PROJECT **GODREST RESIDENCE**  
120W Toorak Rd  
South Yarra, VIC

## PLANNING PERMIT APPLICATION DELEGATE REPORT

Those plans include Drawings TP01 to TP20 inclusive dated 18 March 2022 by Powell & Glenn and Landscape Plans TP\_01; TP\_02; TP\_10-13; TP\_35; and TP\_50 dated 20 December 2021 by Myles Baldwin Design.

Figure 6: Ground floor demolition plans (Source: Applicant)

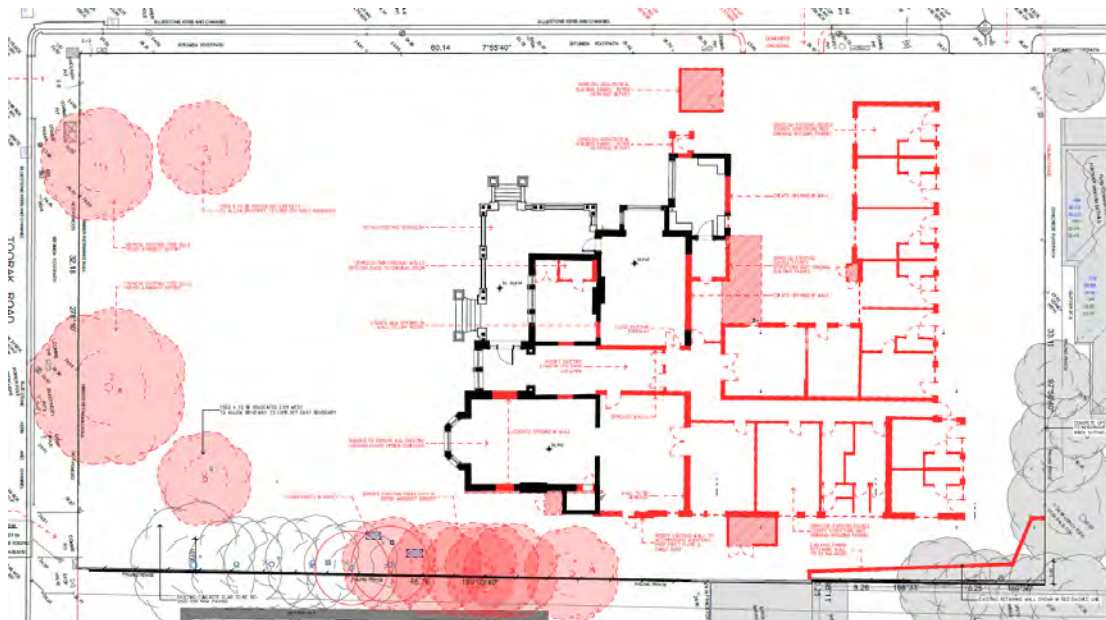
The two Canary Island Date Palms towards the front of the Site are proposed to be retained in situ, according to the applicant's Town Planning Report. However, the demolition plans indicate that these trees will be relocated.

**Figure 17: Location of Bhutan Cypress trees to be removed (circled) (Source: Applicant)**

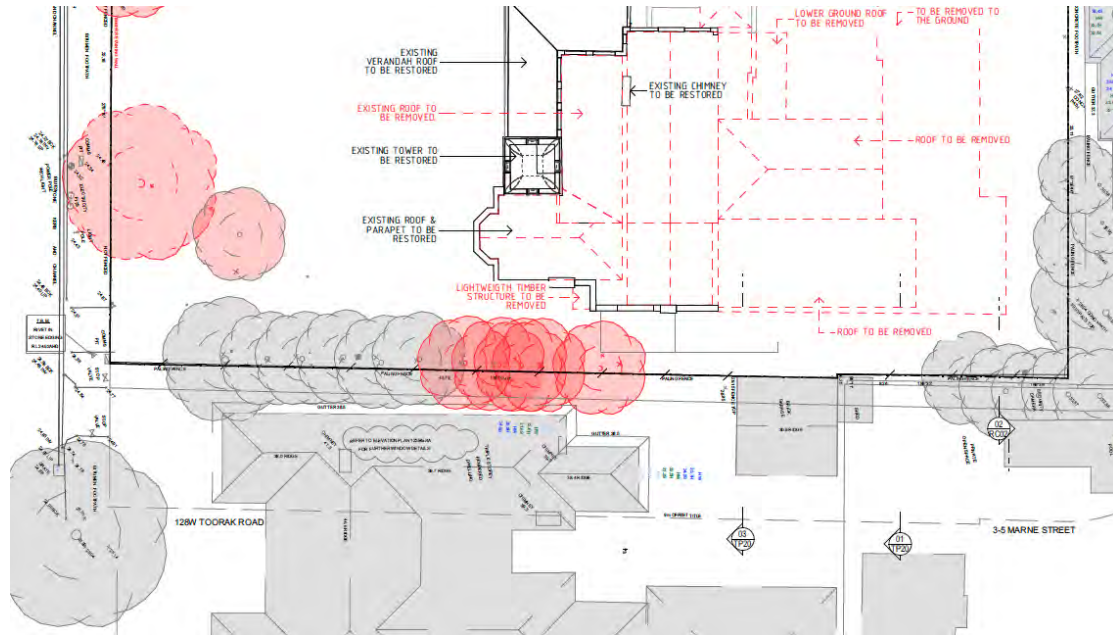
The application seeks approval for the removal of the 5 most northern trees in the row of Bhutan Cypress trees located on the east boundary of the Site. The row includes a total of 11 trees, all which are included in the Table at Schedule 2 to the Environmental Significance Overlay; in the City of Melbourne Exceptional Tree Register 2012 (as amended in 2014) (ETR), which is a reference document in the Melbourne Planning Scheme; and included in Schedule 6 to the Heritage Overlay.

Council's Urban Forestry and Ecology team have reviewed the proposal on several different occasions and provided advice that the extensive pruning of the eastern canopy of the trees in question has greatly reduced the amenity of the trees but that their visibility from the public realm mean they still contribute to the landscape character of the area.

The applicant has provided evidence to demonstrate that the trees were not part of the original planting on the Site and more likely to be a much later addition. They also cite the location of trees, set well back from the Toorak Road boundary, as meaning their landscape value is further reduced.

For the reasons outlined above, removal of the rear 5 Bhutan Cypress trees is appropriate. Conditions of permit, including a Tree Protection Plan, will ensure the long-term retention of remaining significant trees on the Site. Extensive landscaping on the Site will also make a significant contribution to the landscape character of the area, balancing the loss of significant trees.

Figure 18: Location of Trees 5 and 6 TPZ in blue and SRZ in orange (and highlighted for clarity) as per advertised plans (Source: Applicant)

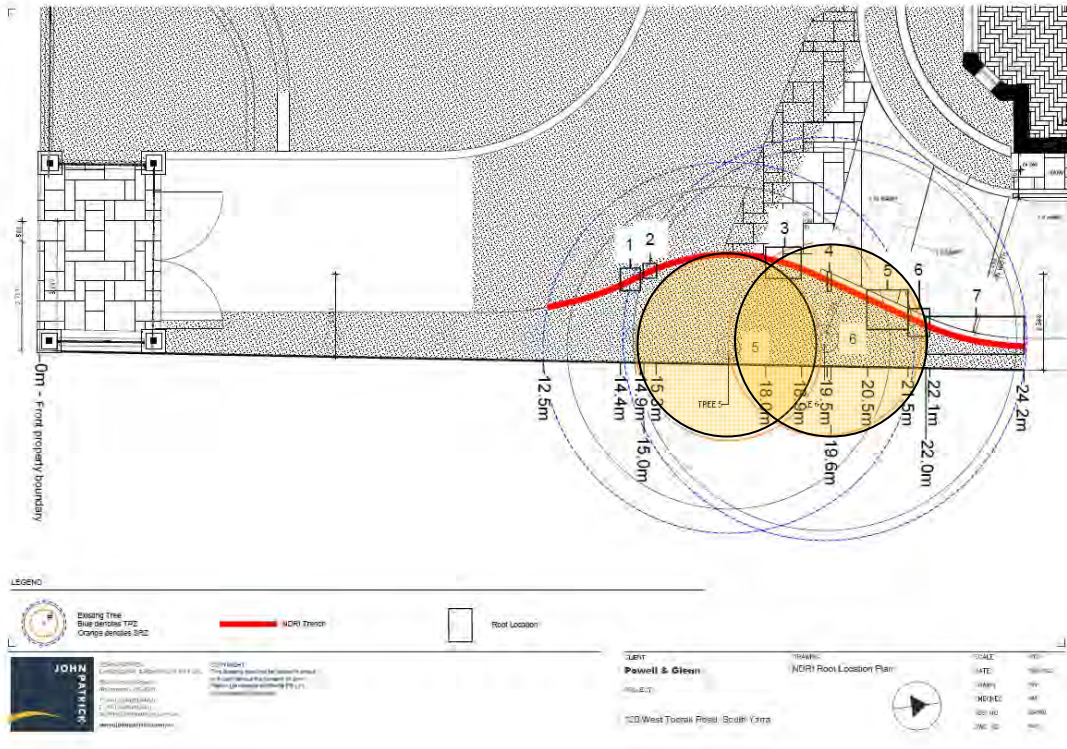
Council's Urban Forestry and Ecology team raised concern with the proximity of the driveway, and associated works to construct it, to the rear most trees to be retained, Trees 5 and 6. Most recent advice suggested the basement ramp needed to be amended to ensure no encroachment of works into the SRZ of those trees.

The applicant has responded to this advice, formally amending the application via s.57A to amend the basement ramp and driveway so that works will not result in the cutting of roots in the SRZ.
